SOUTH JORDAN CITY COUNCIL STAFF REPORT

Item Name	Almond Dental Phase 2 Parking Reduction
Address	10435 S. 2200 W.
File Number	PLSPR202400093
Applicant	Jeffrey Almond
Property Owner	Miner Cove LLC
Staff Author	Damir Drozdek, Planner III
City Engineer	Jared Francis, Senior Engineer
Presenter	Brian Preece, Director of Planning and Economic Dev.

H.1. NEW TWO STORY COMMERCIAL BUILDING SITE PLAN "ALMOND DENTAL PHASE 2"

File No: PLSR202400093

Concept Site Plan

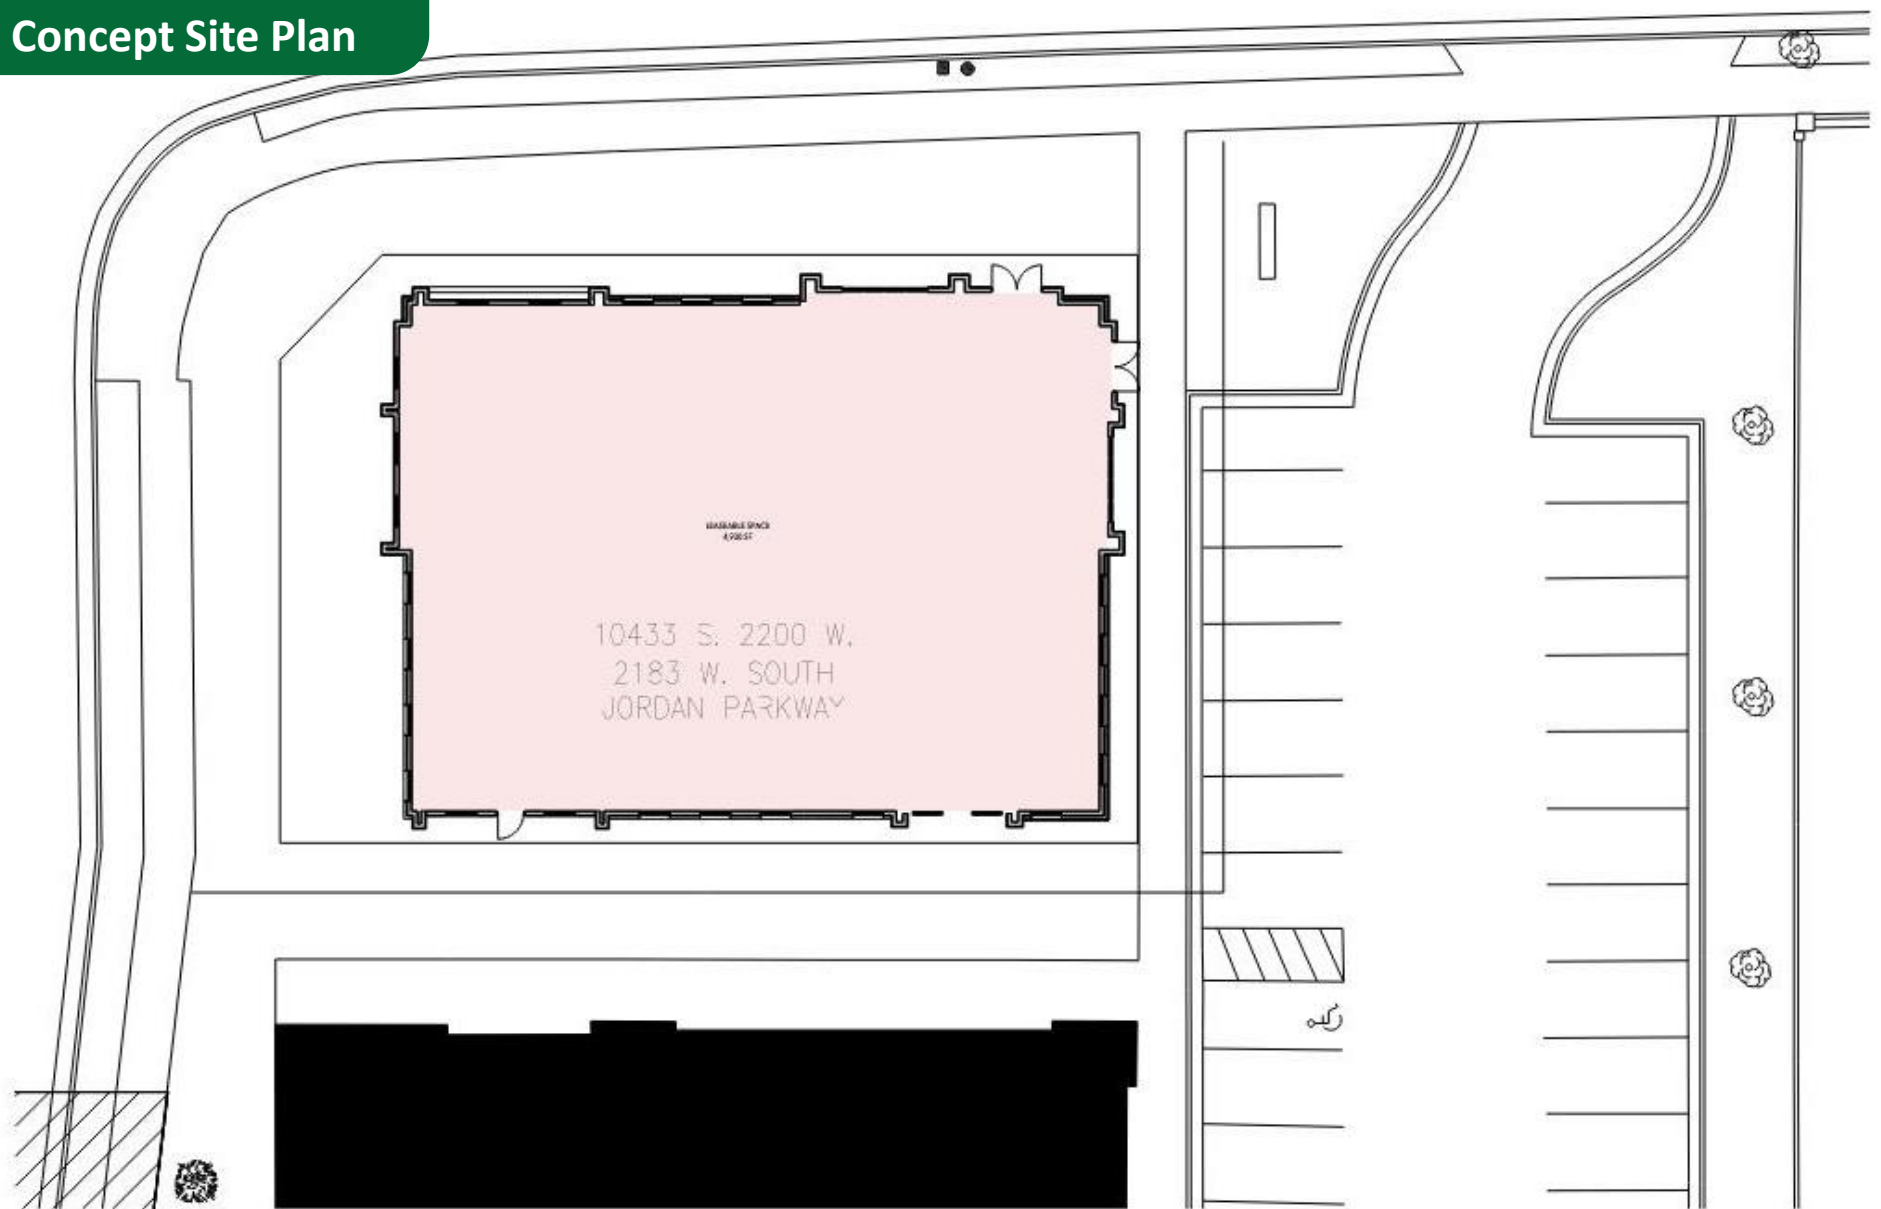
Commissioner Harding said so the grass section that comes off of South Jordan Parkway is that a required length of "no parking" so if I'm reading correctly, that sign can be moved. Could additional parking be put between where that sign is?

Commissioner Harding said and then at the same time if you go to the corner where the image shows all of the parking off of 2200 South, is there any requirement to have so many feet to the street there?

Commissioner Harding said could they move the garbage over there and add parking to that?

Planner McDonald said they do have two on the south side of phase two, and two on the east side. Those two on the east side have to be removed and relocated further north to meet those requirements of access distance to that entry on the northeast corner of that building.

Planner McDonald said they wouldn't be able to occupy that easement. It has active services in it, there are actual junction boxes installed there as well.
